AGENDA
CHARTER TOWNSHIP OF MERIDIAN
PLANNING COMMISSION – REGULAR MEETING
April 13, 2026 6:30 PM

Re: **Special Use Permit #26007 (Tailgaters)**, to construct a Tailgaters gas station and convenience store at 1614 and 1622 Grand River Avenue and a vacant parcel on Central Park Drive.

1. Proposed Site Plan, prepared by PEA Group

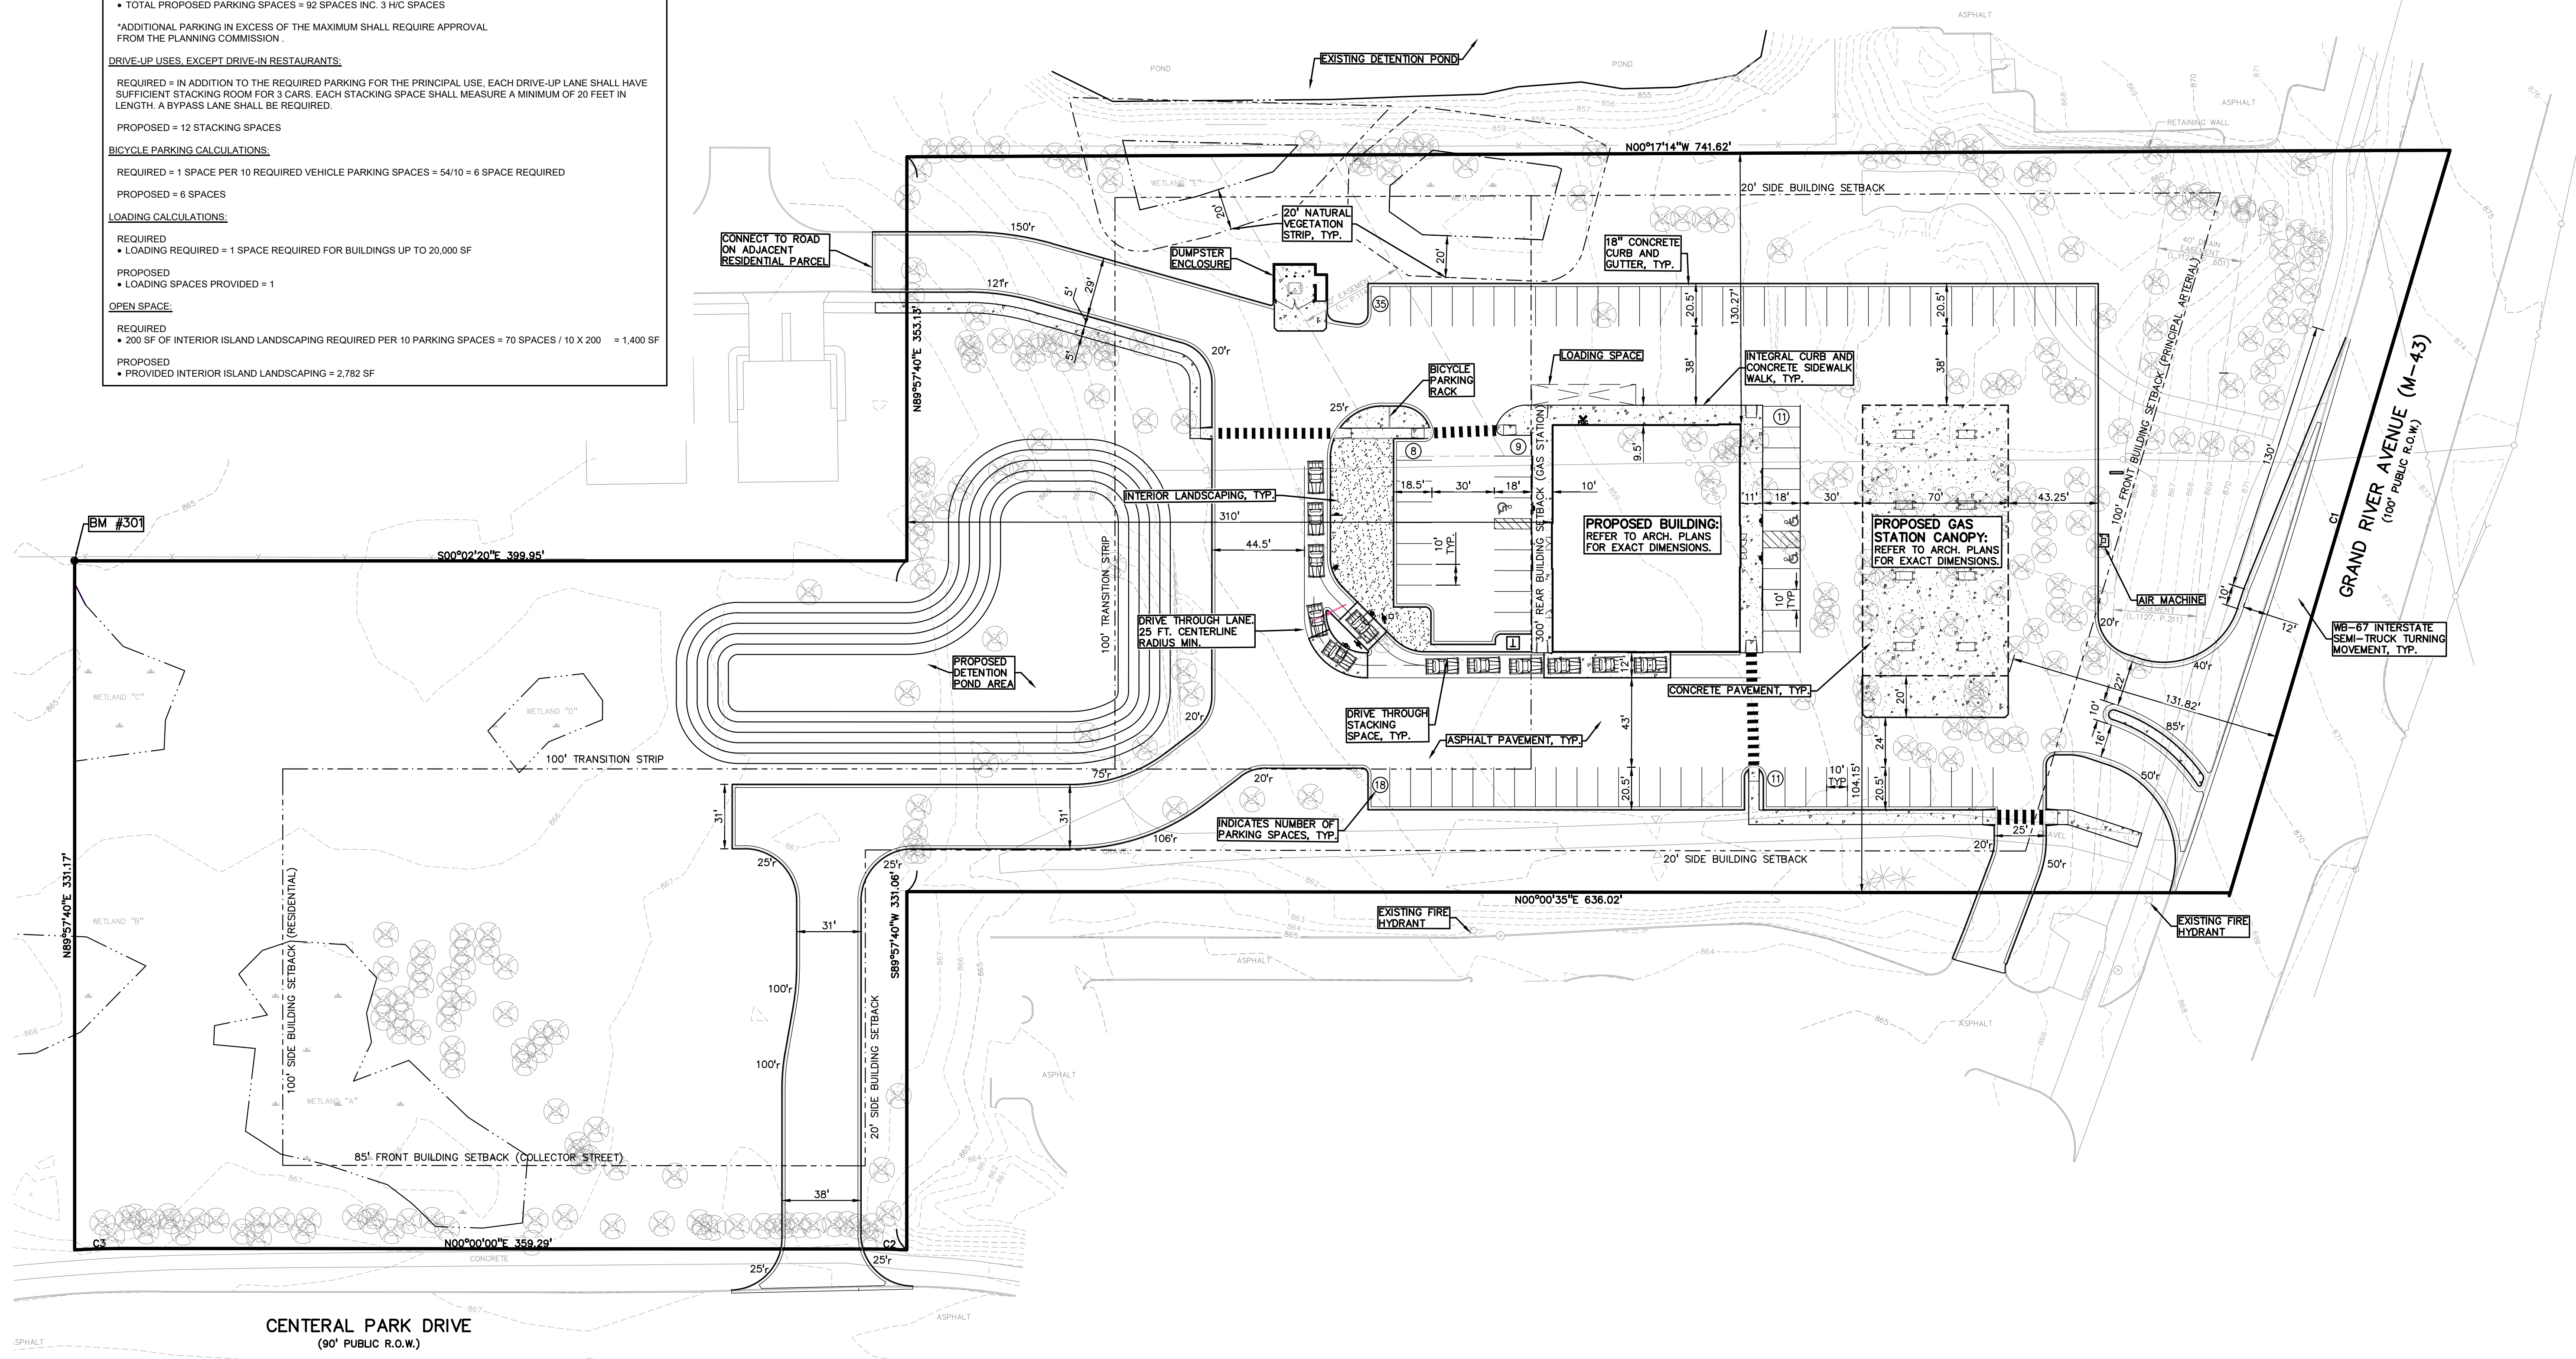
The attached proposed site plan shows that the Applicant is complying with the dimensional requirements in the Township Zoning Ordinance. However, if the proposed site plan moves forward as drawn, two variances will be necessary for approval:

1. The parking calculations on the proposed site plan indicate that there is a maximum of 54 parking spaces allowed. However, 92 spaces are proposed. First of all, the parking calculations do not include the required parking for the gas station, which requires one space for each bay and one for each employee on a shift. There are 16 bays shown, and it is assumed that two additional employees would be necessary for the operation of the gas station. The proposed development requires an additional 18 parking spots, for a maximum of 72 spaces. The Applicant will have to receive a variance from the Zoning Board of Appeals (ZBA) for the 20 extra parking spaces. The site plan erroneously states that the Planning Commission can waive the extra parking, and this note needs to be removed from the proposed site plan.

2. The standards for gas stations in the C-2 zone state that no more than 10 vehicle fueling stations are allowed. A fueling station is defined as each location at a gasoline pump where one motor vehicle may be fueled, meaning that each pump contains two stations. The proposed site plan shows eight pumps, resulting in 16 fuel stations. A variance will be required for the extra 6 fuel stations.

As noted above, the Applicant is proposing 16 fuel stations and will require a variance before site plan approval.
